Date: 28th February 2026
Our Reference: JH.250509.AIA
Your Reference: 320 HMA

Supplementary Arboricultural Impact Assessment for UKHMLC Planning Application 19/00114/FULL

Figure 1: Snipped Image from Courtyard Long Sections Drawing

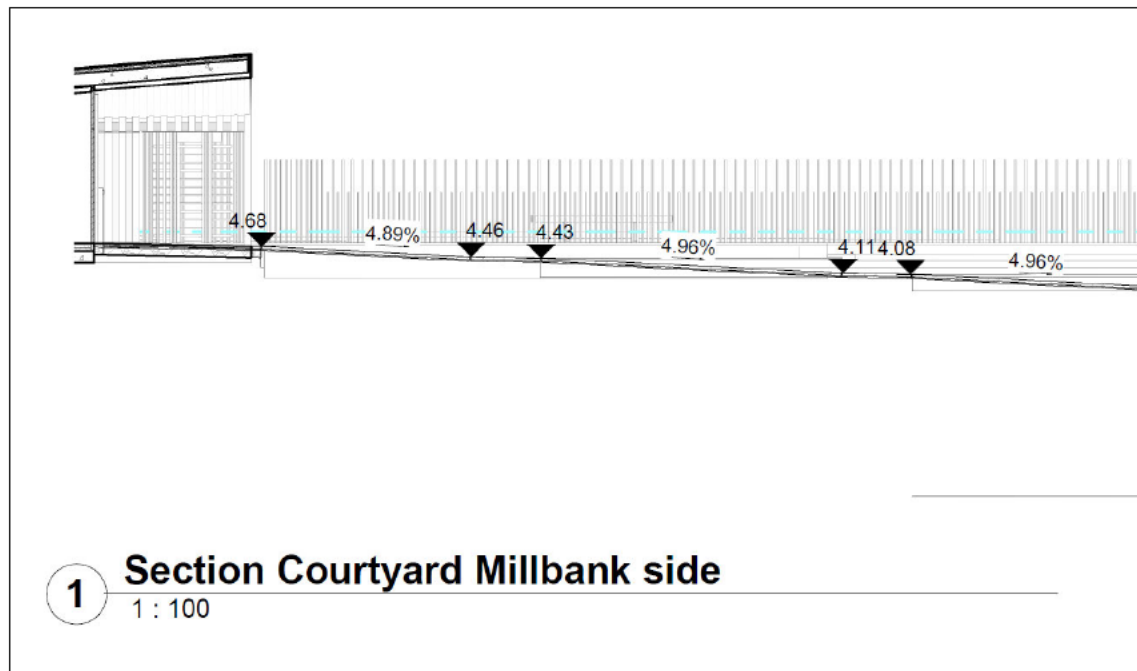
- 5.1.1 Section 5.3.4 of my original impact assessment had two tables, detailing impacts of the excavation envelope on the known tree root systems. As set out above, the scope of works required for the courtyard has been updated. The updated levels of the excavations required for the Courtyard are shown in Figure 1 & Figure 2 below, and those original assessment tables have been updated accordingly..

Tree Ref	Root Ref	Diameter & Depth	Aspect of Memorial	Implications
T71022	R25	50 mm 900 mm	Entrance Pavilion	Pruned during excavations (no change from original application)
T71021	R24 – R22	40 mm – 30 mm 900 mm – 1.0 metre	Entrance Pavilion	- Retained 100 – 300 millimetre excavation for foundations - Above existing roots - No pruning or direct damage anticipated (no change from original application)
T71020	R21 – R19	60 mm – 20 mm 800 mm – 900 mm	Pavilion Courtyard	- Retained - Sloping courtyard 2^o gradient 300 – 500 millimetre cut for levels - Proposed changes to incorporate roots - Root R19 dead at time of investigation (no change from original application)
T71019	R18 - R16	15 mm – 40 mm 800 mm – 1.0 metre	Pavilion Courtyard	- To Be Retained - Sloping courtyard 2^o gradient 300 – 600 millimetre cut for levels anticipated - Proposed change to incorporate roots (no change from original application)

Figure 2: Snipped Image from Courtyard Long Sections Drawing Showing Thames River Elevation

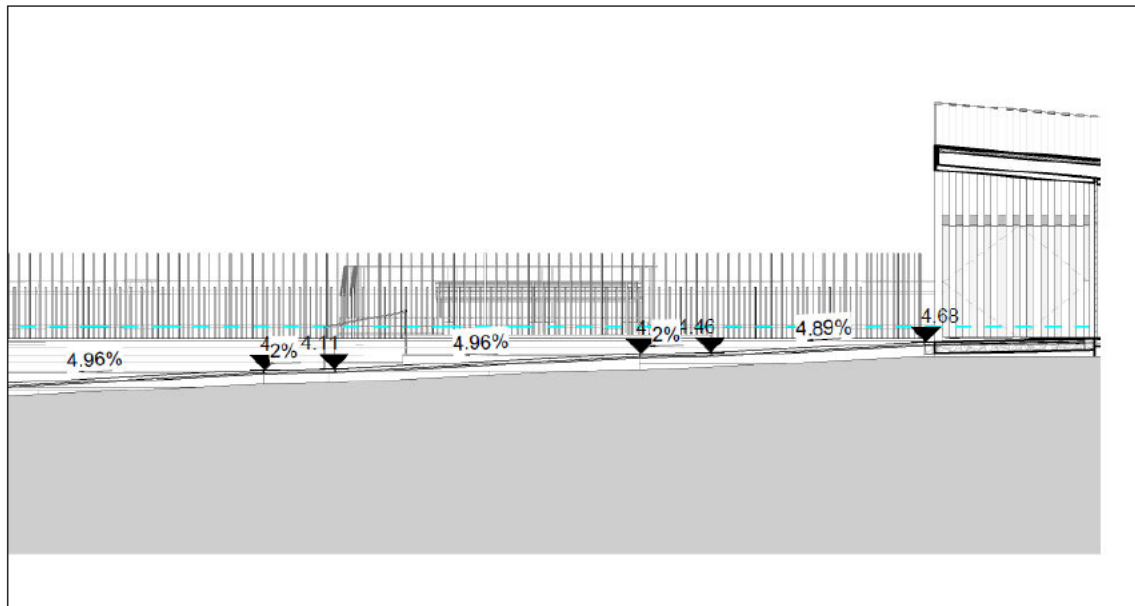
Tree Ref	Root Ref	Diameter & Depth	Aspect of Memorial	Implications
T70006	R26 – R27	· 50 mm – 20 mm · 400 mm – 600 mm	· Pavilion Courtyard	· Sloping courtyard 2 ^o gradient · 300 – 500 millimetre cut for levels · Root 26 likely need to be pruned · Root 27 likely retained (change from original application)
T70007	R28	· 30 mm · 1.0 metre	· Pavilion Courtyard	Retained · Shallow building foundations above roots · No pruning or direct damage (no change from original application)
T70008	R29 – R30	· 35 mm – 40 mm · 700 mm	· Pavilion Courtyard Basement Box	· Pruning required to facilitate development (no change from original application)

5.1.3 Further to this detailed study and review, there are two material changes from the original application:

- pruning of root R26 as a result of excavations required for the courtyard
- pruning of root R28 as a result of excavations required for the courtyard

5.1.4 Impacts of root pruning have been addressed in the original & supplementary impact assessments; and based on the above review, those impacts will remain the same.

5.1.5 As per the original impact assessment, and confirmed by the project engineer at the time of writing this report, drainage and construction of the pavilion courtyard will look at ways to ensure rainwater filters through to the soil and rooting environment below, as well continued gaseous exchange to the soil for continued root growth and development; and pruned roots and the trees will be subject to compensation & mitigation.

Figure 3: Snipped Image from Root Investigations Showing Location, Depth and Diameter of Roots

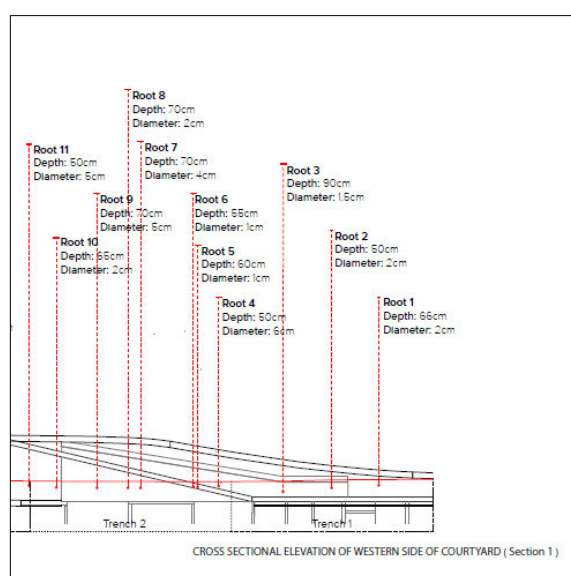
- 5.3.3 With regards to drawing UKHM.WSP.ZZ.ZZ.DR.DR.900102, Revision P02, although service runs and corresponding inspection chambers are proposed and sited within the root protection area and known rooting location, they are broadly below the roots.

- 5.3.4 Final layout and siting of services will need to be guided and informed by supplementary investigations detailed as part of the arboricultural method statement; and installation methods including trenchless techniques such as thrust-boring and / or impact-moling will need to be specified to prevent root damage and severance.

Figure 4: Snipped Image from Service Plan Highlighting Overlap and Trespass with Known Rooting Locations

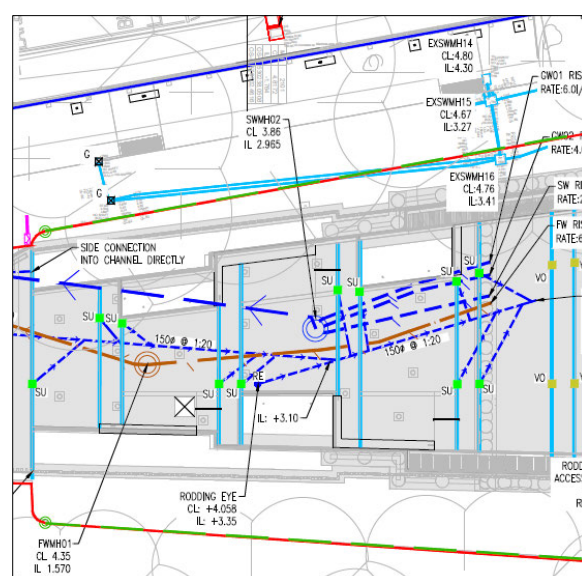
- 5.3.7 With regards to the same drawing UKHM.WSP.ZZ.ZZ.DR.DR.900101, proposed service runs are currently sited and trespassing through the root protection area and knowing rooting locations. As stated above, final positioning and location of these runs will need to be determined and finalised following supplementary investigations detailed as part of the arboricultural method statement.

- 6.3 After my review of the proposed service plans, there has been positive progress in rationalisation and siting of the drains, runs and inspection chambers. However, there remains some overlap and conflict which will need to be finalised through supplementary investigations and modification of design and layout, detailed as part of the future main contractor's arboricultural method statement.

- 5.3.8 It is my professional recommendation that service runs are shared to minimised intrusion and working within the rooting environment; with final working methodologies to be detailed in the arboricultural method statement.
